19 February 2021

**Application to modify SSD 10349**  
**Multi-Trades and Digital Technology Hub, TAFE NSW Meadowbank Campus, Meadowbank Education and Employment Precinct**

Figure 1: Tree Location Plan

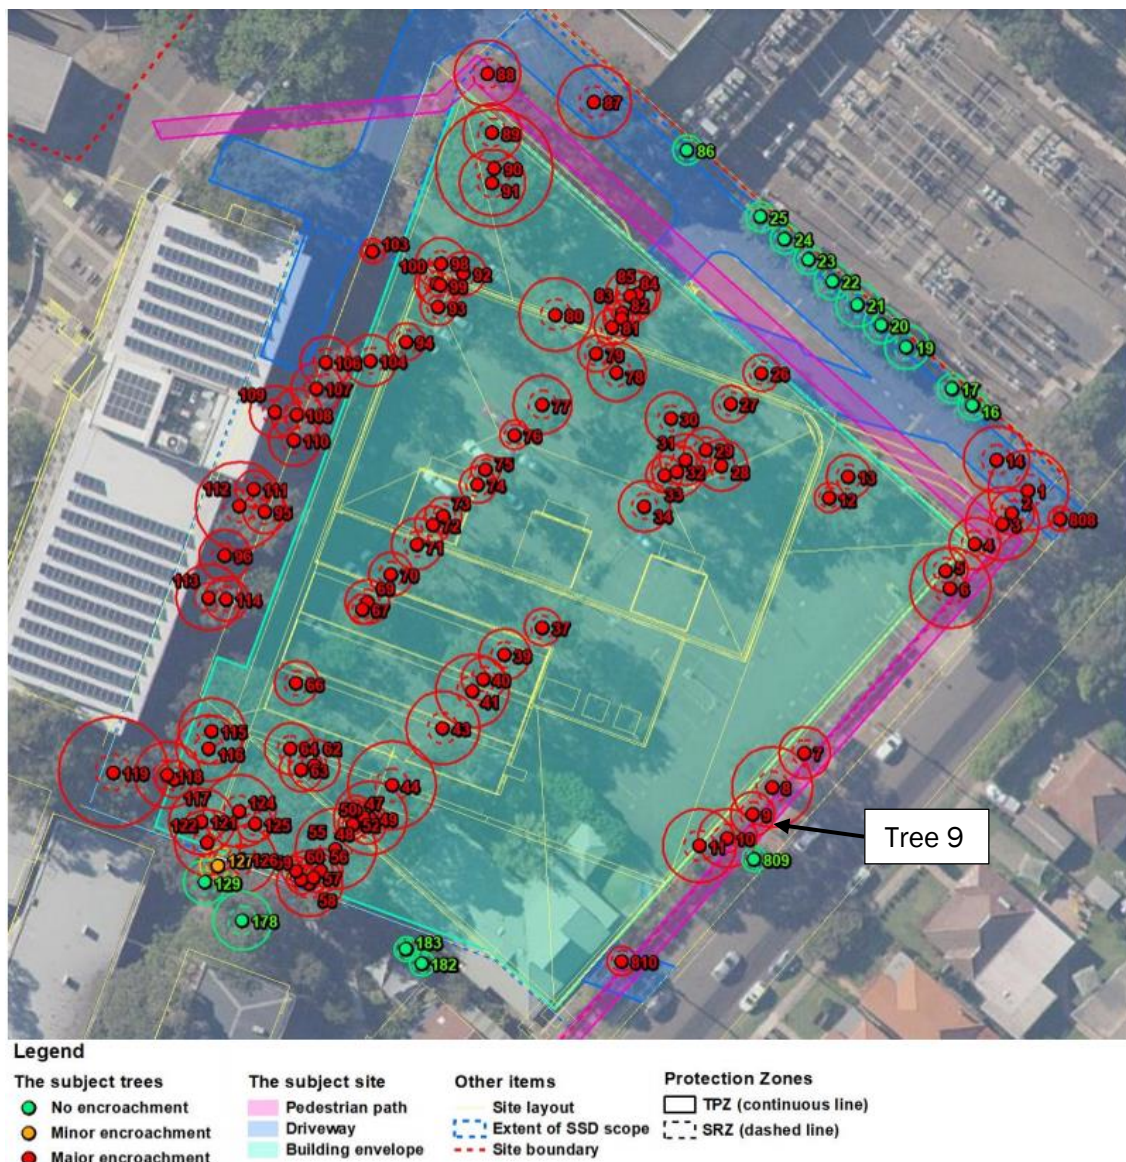
As illustrated in Figure 1, Tree 9 is located to the eastern boundary of the MTDTH, adjacent to See Street. As detailed in the AIA MTDTH (Appendix 1) Tree 9 is a Eucalyptus Scoparia with a height of 10 metres and a spread of 6 metres. The health of this tree is identified as good and its significance is low.

Detailed design refinement has revealed that excavation works for footings and a batter associated with the MTDTH will impact upon the Tree Protection Zone of this tree and therefore it can no longer be successfully retained.

As illustrated in Figure 2, Trees 212 and 216 are located to the north of the exit ramp of the Block J car park.

Tree 212 is a Corymbia Maculate, with a height of 10 metres and a spread of 6 metres. Tree 216 is a Lophostemon Confertus with a height and spread of 10 metres. The AIA Block J Car Park (Appendix 2) identifies both trees are in good health with medium significance.

Following the approval of SSD 10349, it has become apparent that the revised location of the Block J car park encroaches on the Tree Protection Zones of Trees 212 and 216 and consequently they can no longer be successfully retained.

The revised AIA MTDHT therefore recommends removal of this tree.

The revised AIA Block J Car Park therefore recommends removal of these two trees.
